**Consultation Response from KC,
Highways Development Management**

**2024/91760 Land adj Healey Junior Infants and Nursery School, Healey lane, Healey, Batley,
WF17 8BN**

**Erection of 19 dwellinghouses with associated car parking, landscaping and boundary
treatment and other associated associated works**

Date Responded: 21/10/2024

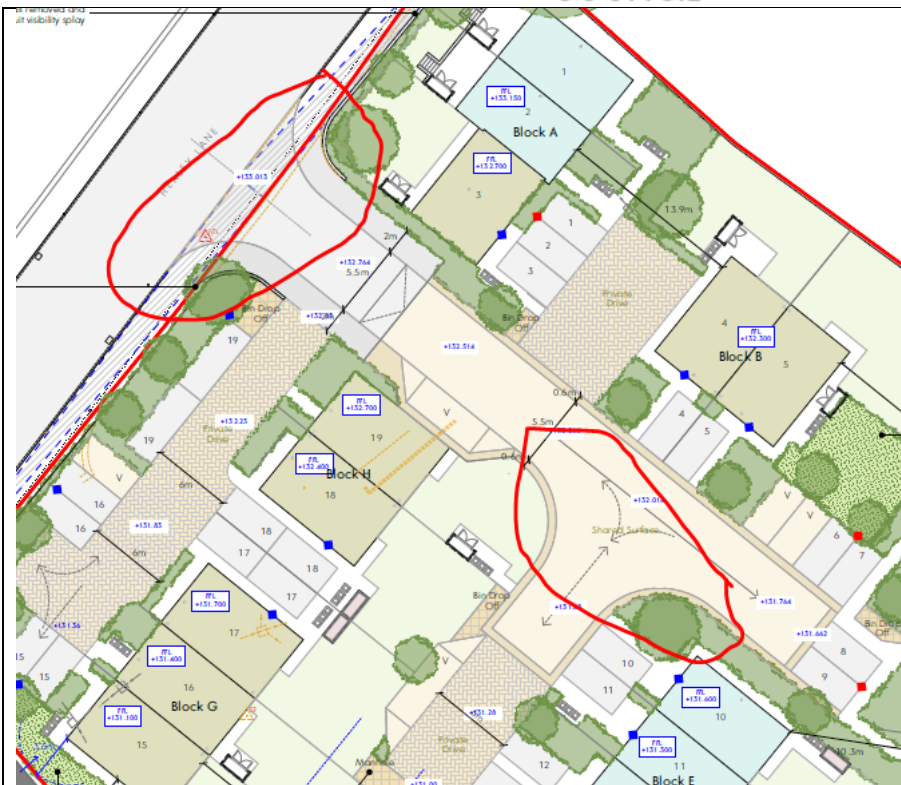
There are no other pedestrian access routes in to the site and for sustainability reasons we would like to see a pedestrian access on to West Park Road that would create a shorter route to bus stops. With just the proposed shared vehicular/pedestrian access the walking distance from the centre of the site to the closest eastbound stop is approximately 300m, with a pedestrian route directly on to West Park Road this could be reduced to approximately 165m. Westbound stops are slightly closer to the site. This would increase the attractiveness of public transport to residents on the site.

Table 1: Summary of Residential Street Types

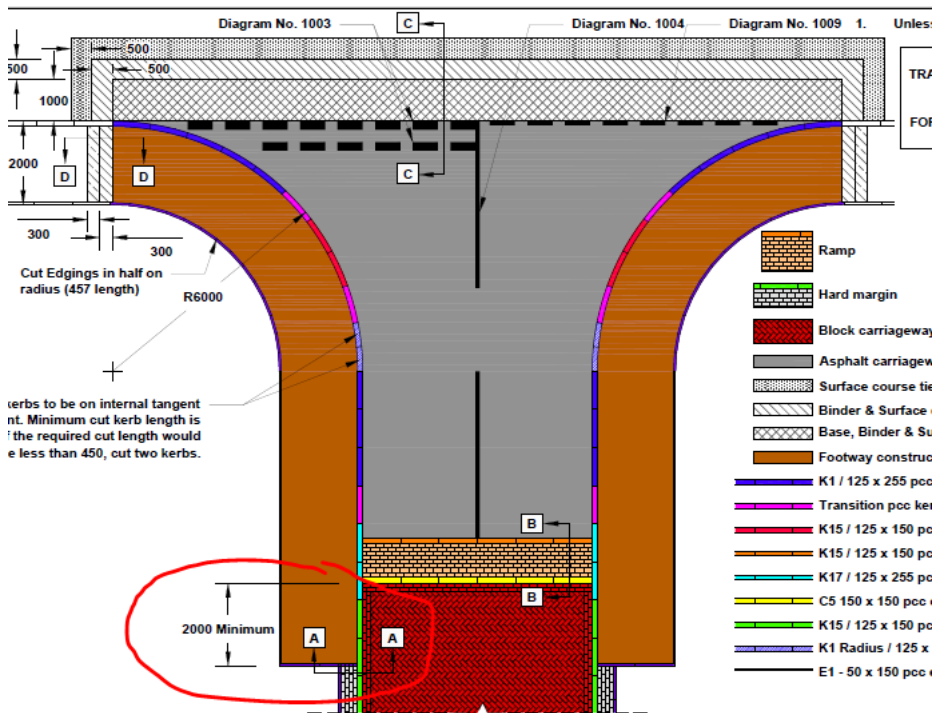
Where there is not a footway adjacent to the carriageway a minimum 5.5 metre wide shared surface (Type C) block paved carriageway with a minimum 600mm block paved margin on either side is required as per Table 1 and paragraph 3.14 of the Design Guide. Shared surface carriageway must not be steeper than 1:21 or 5% otherwise a Local Residential Street (Type B) with footways on both sides

will be required.
